MIDLAND NUCLEAR COGENERATION PLANT
MIDLAND DOCKET NOS 50-329, 50-330
B&W STEAM GENERATOR AUXILIARY
FEEDWATER HEADER DESIGN CHANGE
FILE: 0.4.9.62, 0505.2 SERIAL: 19403

This letter provides another interim 50.55(e) report concerning the B&W steam generator auxiliary feedwater header. Consumers Power Company and B&W are in the process of implementing the design modifications as designed and presented in an earlier 50.55(e) report, reference 2.

B&W CODE ANALYSIS OF THE INTERNAL AFW HEADER

FIG. 1 COMPLETE 360° F.E. MODEL

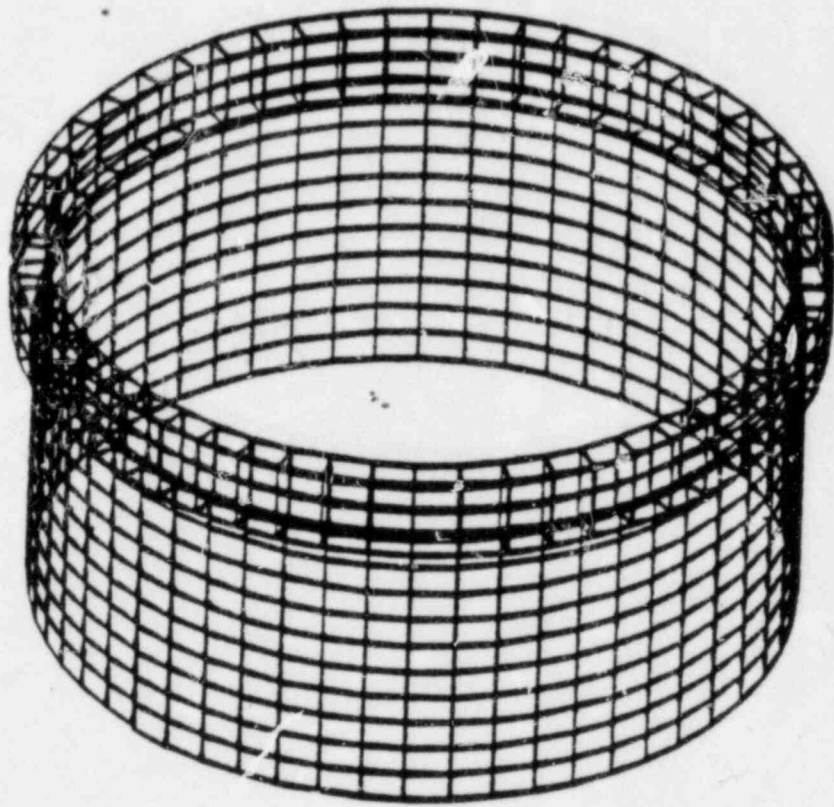
The stabilized header is subjected to loads which cannot be simulated using axisymmetric models. To provide adequate accuracy, the header, eight attachment points and an attenuation length of the shroud were modeled as a three dimensional structure using the ANSYS Finite Element Code. The header was modeled using quadrilateral plate elements to represent the four sides of the header. The circumference of the header was divided into 54 elements with nodes separated by an average of 6.7° . The shroud was also modeled using quadrilateral plate elements and included one dimensional elements at eight node points around the circumference to simulate the alignment pins and their interaction with the steam generator shell. The two structures are connected at eight locations by the use of tie-nodes to represent the welded attachments. In order to avoid excessive computer time the shroud was treated as a super element and thus specific results are not available for it. Figure 1 shows the full 360° model which was used.

Fig. 2

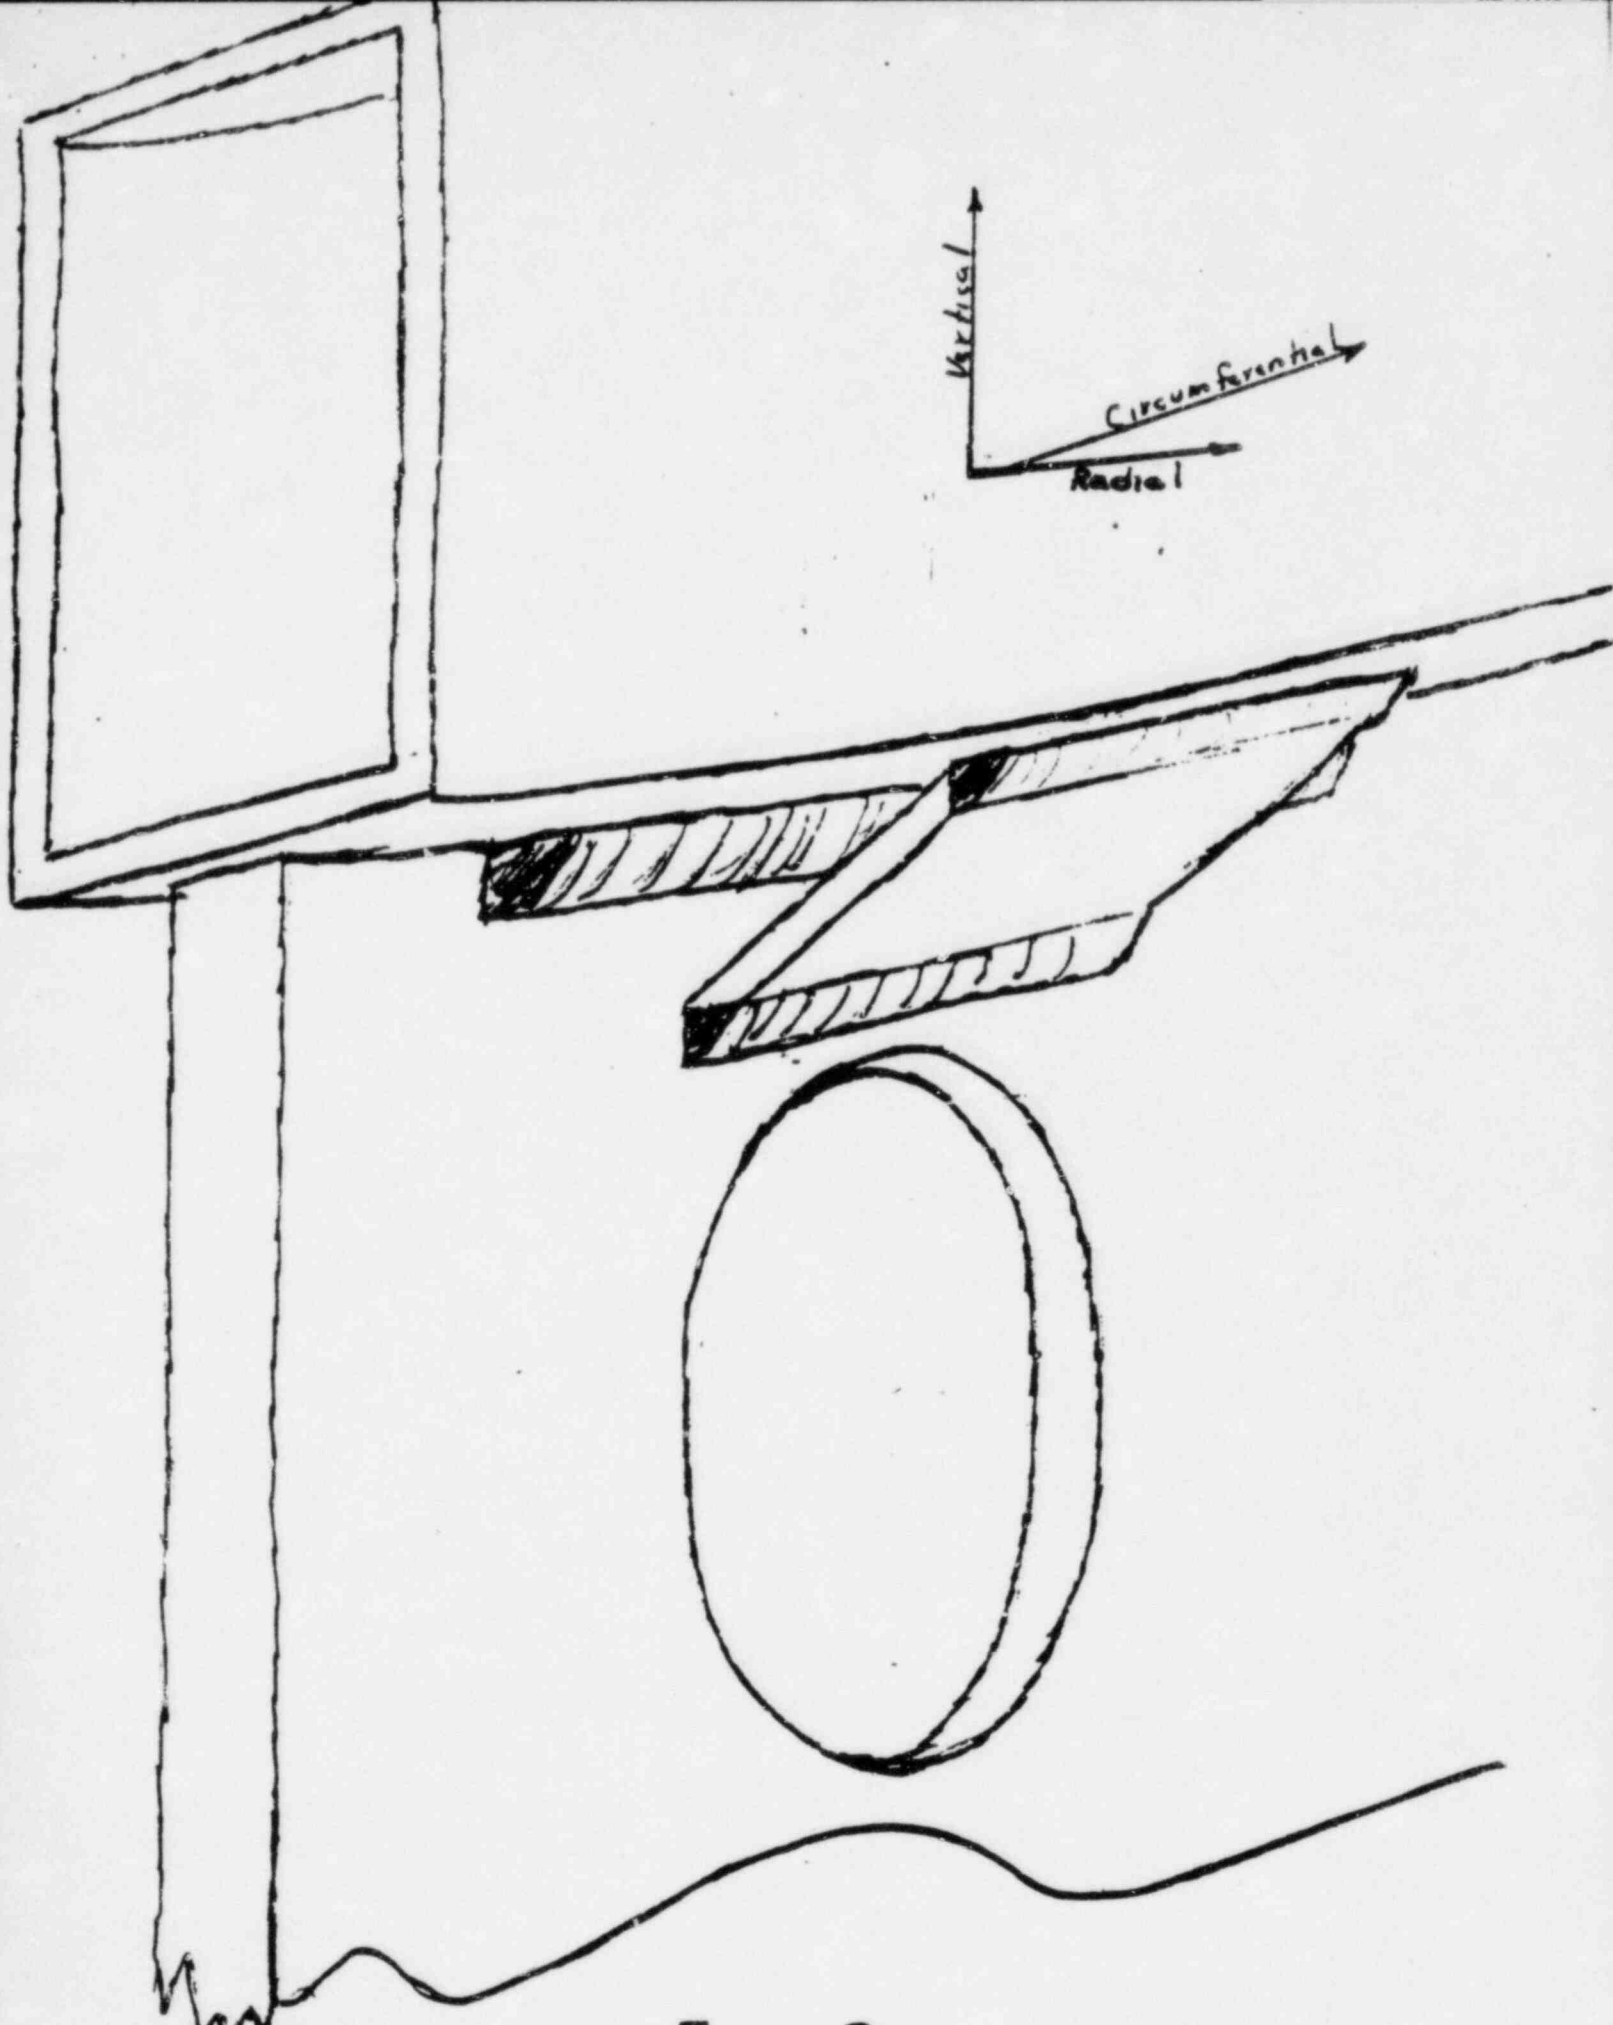
The internal header attachment design provides eight attachment points between the header and shroud. Each of the attachment points is located near one of the shroud alignment pins. The attachment is provided by a large fillet weld between the shroud and header in the corner formed by the two parts. In addition, a gusset plate is welded between the bottom of the header and the side of the shroud. The attachment design is shown in Figure 2.

The model was created primarily to determine the loads imposed on the re-designed connections between the header and shroud. Because of the geometry of the welded attachment, shown in Figure 2, the calculation of the stress intensities from the load and moment vectors required assumptions as to the way the welded attachments would carry the load.

The weld area of the fillet weld is taken to be the theoretical throat times the length. The weld area of the gusset welds is taken to be the thickness times the length. For both welds a weld quality factor of 0.5 is used as is recommended for a fillet weld in Section III Subsection NB paragraph 3356 of the ASME Code 1977 Edition, Summer of 1978 Addenda.

The header attachment welds are adequate for all anticipated loads. The requirement for these attachments is to hold the header in place atop the shroud and for Level A, B or C Conditions to prevent contact between the header and tubes. The attachments provide sufficient rigidity to satisfy this requirement. For Level D, the requirement is no tube rupture. The attachments by preventing the header from breaking loose avoid any potential for the header to cause tube rupture.
